HISTORIC AND DESIGN REVIEW COMMISSION

HDRC CASE NO: 2017-338
ADDRESS: 914 N PINE ST
LEGAL DESCRIPTION: NCB 1653 BLK A LOT E 1/2 OF 5
ZONING: R-5, H
CITY COUNCIL DIST.: 2
DISTRICT: Dignowity Hill Historic District
APPLICANT: David Ericsson
OWNER: David Ericsson/Pine 14 LLC
TYPE OF WORK: Porch reconstruction, exterior modifications and modifications to building entrances

LEVEL 1_AFTER - PORCH DETAIL

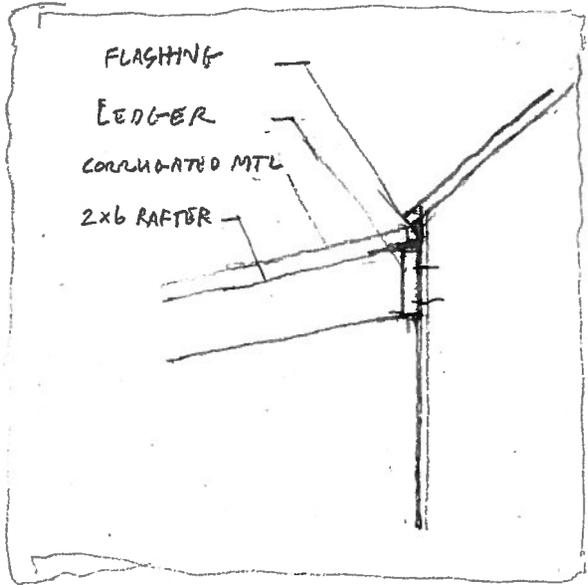
- e. SIDE DOOR AT FRONT PORCH– The applicant has proposed to enclose to side facing front porch door. Per the Guidelines for Exterior Maintenance and Alterations 6.A.i., existing window and door openings should be preserved. Additionally, two front porch doors is vernacular architectural element to San Antonio. The proposed enclosure of the side facing front door is not consistent with the Guidelines.

- g. SIDE PORCH DOOR REMOVAL – The applicant has proposed to replace the existing, side porch door with a window. Per the Guidelines for Exterior Maintenance and Alterations 6.A.i., existing window and door openings should be preserved. Given the location of this door and its relationship to the front façade of the structure, staff finds its removal to be inconsistent with the Guidelines and inappropriate. Staff recommends the applicant maintain the existing porch door.

- h. SIDE PORCH WINDOW REMOVAL – The applicant has proposed to replace one of the existing, north facing side porch windows with a door opening. The Guidelines for Exterior Maintenance and Alterations 6.A.i. notes that existing window and door opening should be preserved. While the existing window will be removed, staff finds the opening will remain. The proposed new door should match those found historically on the structure.

Staff does not recommend approval of items #4 and #6 based on findings e, g and h. Staff recommends the applicant maintain these original door and window openings as originally constructed.

WEST ELEVATION

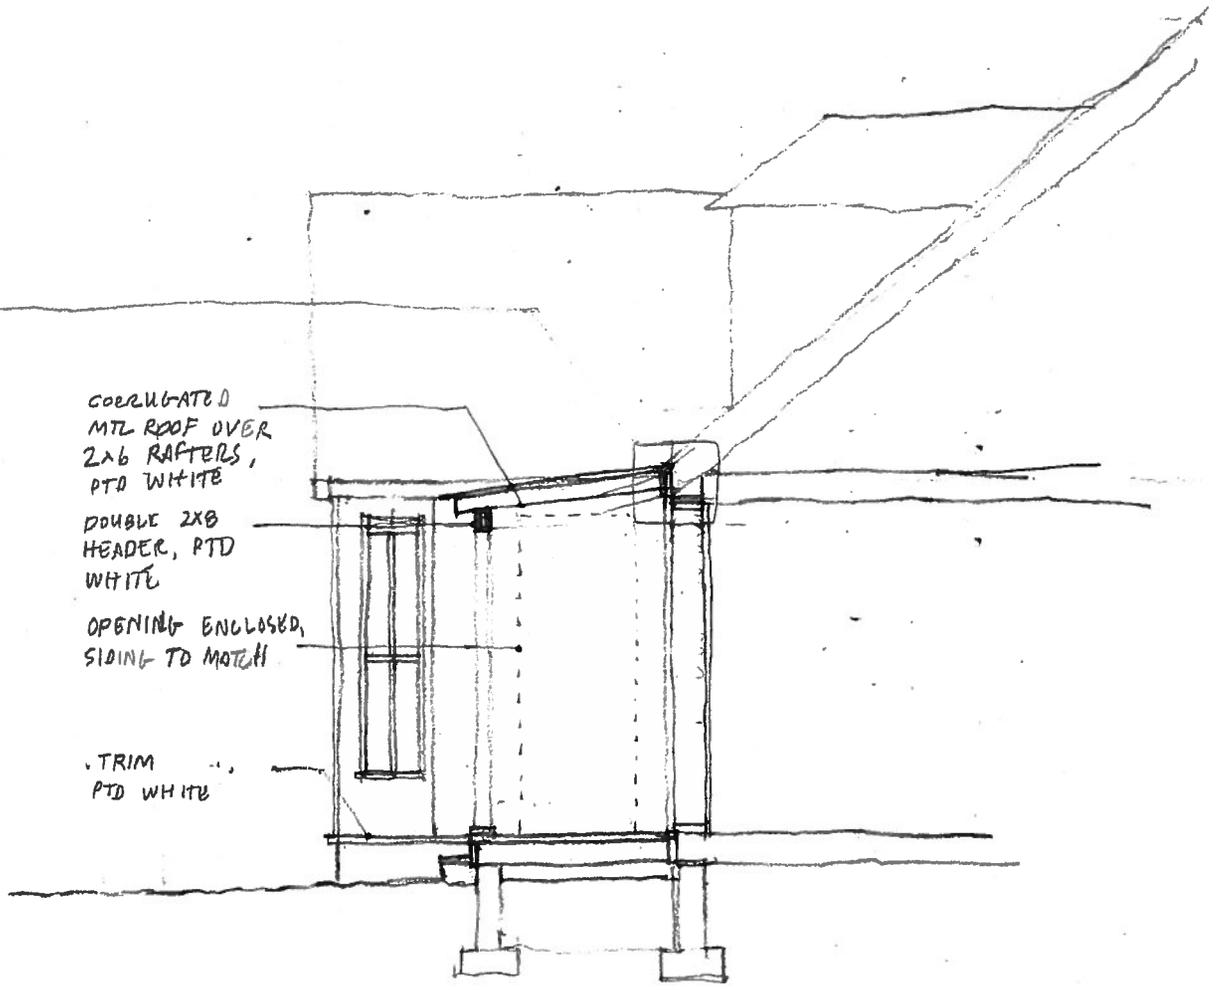
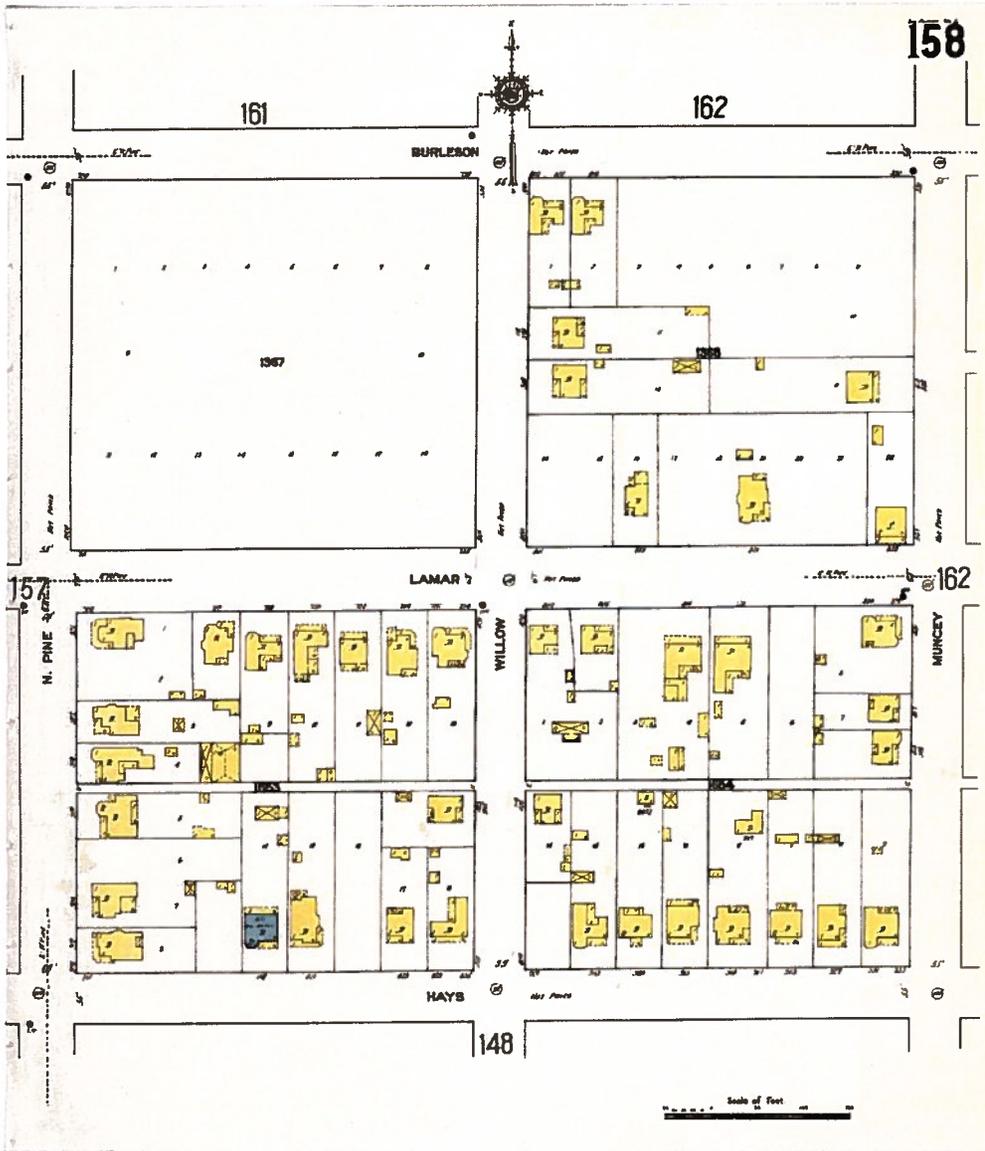
- b. FRONT PORCH – As noted in finding a, the applicant has proposed to reconstruct the front porch. The applicant has proposed for the reconstructed front porch to feature corrugated metal roofing, 2x6 rafters, a 2x8 double header and 4x4 wood columns. Per the Guidelines for Exterior Maintenance and Alterations 7.B.v. porches should be reconstructed based on accurate evidence of the original. Additionally, the design should be based on the architectural style of the building and historic patterns. The applicant has designed the footprint of the porch to closely match that which is shown on the 1912 Sanborn Map.

- c. FRONT PORCH – Regarding details, the applicant has proposed to install 4x4 wood columns, a 2x8 double headers, a corrugated metal porch roof and exposed rafter tails. Typically, Folk Victorian structures features columns of greater mass, unless the columns are spindled. Staff finds that a 6x6 column with base and capital trim would be appropriate. In regards to the porch roof, corrugated metal is not a material consistent with porch roofs in the Dignowity Hill Historic District. The porch roof should feature asphalt shingles to match that of the house or a standing seam metal roof. In regards to the exposed rafter tails, this is an architectural element that is not common to Folk Victorian structures and should be eliminated.

- i. That the applicant install front and side porch columns that are 4x4 square and feature base and capital trim as noted in finding c as well as be chamfered. The applicant is to submit a detail of the porch columns to staff for approval.
- ii. That the applicant install a porch roof that matches that of the primary historic structure as noted in finding c.
- iii. That the applicant eliminate the exposed rafter tails as noted in finding c.
- iv. That the applicant install a transom window that is wood and matches the profile of the existing transom windows.
